Response to U.S. EPR Design Certification Application RAI 403, Supplement 11

Request for Additional Information No. 403(4439), Supplement 11

U. S. EPR Standard Design Certification

**SRP Section: 15.06.05 - Loss of Coolant Accidents Resulting From Spectrum of
Postulated Piping Breaks Within the Reactor Coolant Pressure Boundary**

Figure 15.06.05-61-1: Primary and Secondary Pressures

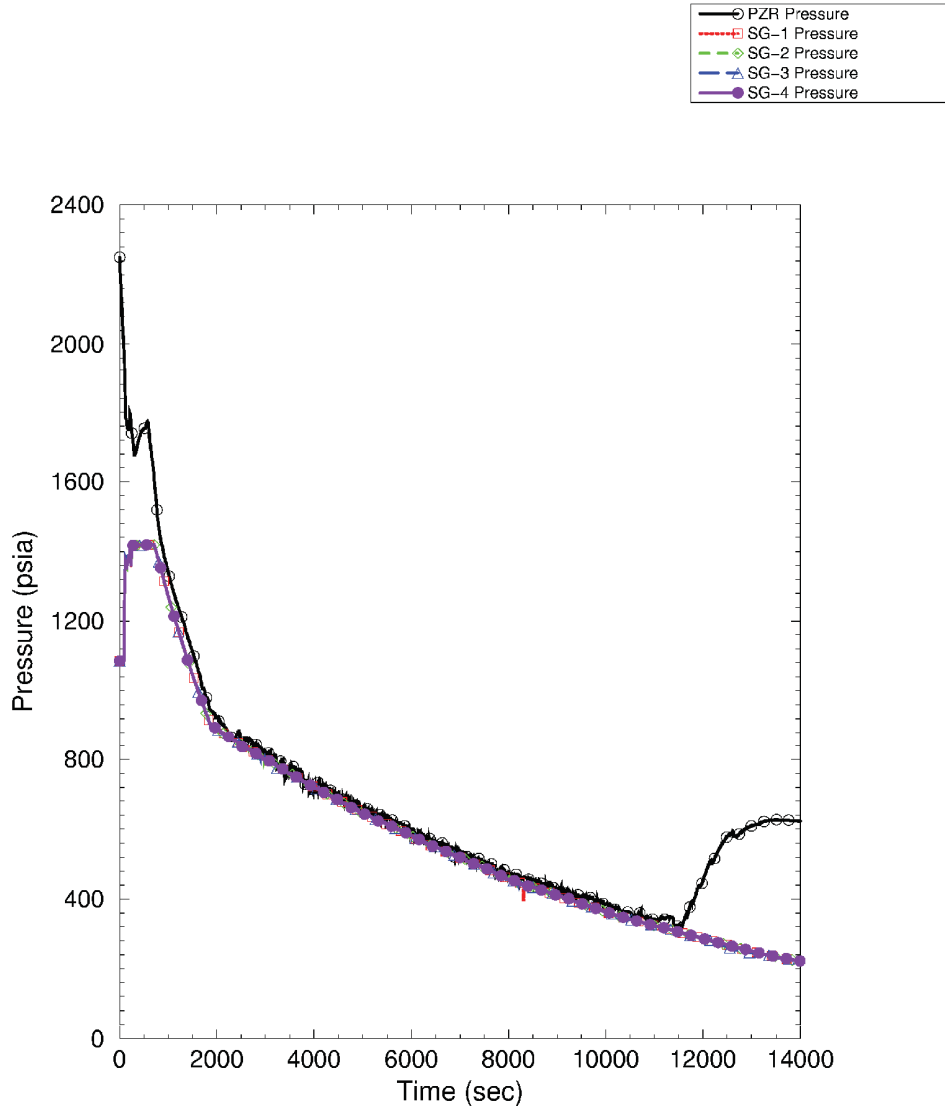
In response to Question 15.06.05-29, the applicant did not provide an assessment of the amount of condensate generated by reflux condensation as was requested. Instead, predictions for the liquid content in control areas defined as “steam generator (SG) outlet plenum,” “loop crossover pipe,” and “cold leg” were presented. Provide a calculation of the amount of condensate generated by reflux condensation accounting for conditions with emergency feed water (EFW) supply present for two or more SGs. The mass of steam due to decay heat is considerably larger than the volume of the loop seals. The staff requests a mass balance accounting for the steam generated in the core by decay heat, steam lost out the break, steam condensed in the SGs, condensate in countercurrent flow returned to the reactor vessel hot leg, condensate collected on the SG, loop crossover pipe, and cold leg, condensate lost out the break, and condensate transported to the vessel downcomer. The staff requests a description of situations involving stratified conditions in the cold leg and downcomer regions.

For the boron dilution event, the most important parameter relative to the reflux condensation is the volume of condensate that accumulates as a coherent, deborated slug. It has been conclusively shown, in the Primärkreislauf-Versuchsanlage (PKL) III tests, that the thermal-hydraulic phenomena occurring during the evolution of the event limit the volume of the slug size to the volume of the loop seal and steam generator (SG) outlet plenum. More discussion on these phenomena, and the applicability to the U.S. EPR plant, is provided in the Response to RAI 403, Questions 15.06.05-62 and 15.06.05-63. The volume corresponds to 11 m³ for the U.S. EPR plant. The total amount of condensate generated by reflux condensation is not unimportant though. The reflux condensation phase must be long enough such that the assumed slug volume can be created. Additionally, the condensate impacts the boron concentrations in the downcomer and in the core. The amount of condensate generated by reflux condensation is highly variable based on break size, system availabilities, and operator actions.
